Minor Changes Key

Project
60 Whitfield Stree

60VVS-A-SBA-DK-XX-4002-C3

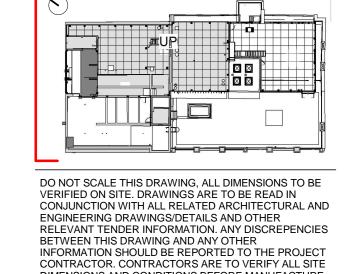
1 Louvre added to enclose MEP

Scope of demolition of existing plant room on Walport building increased

Minor repositioning of approved flues

Maintenance cat ladder added to link
Goldbeaters terrace with Walport terrace

6 Amended stair-landing levels

Parapet of dumbwaiters enclosure raised by 235mm

Reduced louvre height to match Howland Mews elevation

One section of window removed
